# CHI030A ADDENDUM

## CHI030A Output 0 track error

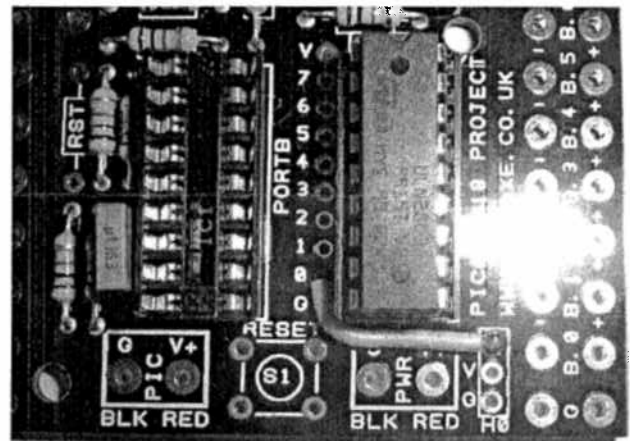
On boards marked 'CHI030A' (label is next to the 3.5mm cable download socket at the top of the board) there is a missing PCB track error that prevents output B.0 working correctly.

Output B.0 of the PICAXE chip is correctly connected to the header between the two chips. However it is not then connected to leg 8 of the darlington driver chip, which in turn stops output B.0 on the right hand side of the board from operating.

1) Solder a wire to connect the '0' pad between the two chips to the top '0' connection of header H0. This provides the missing connection.
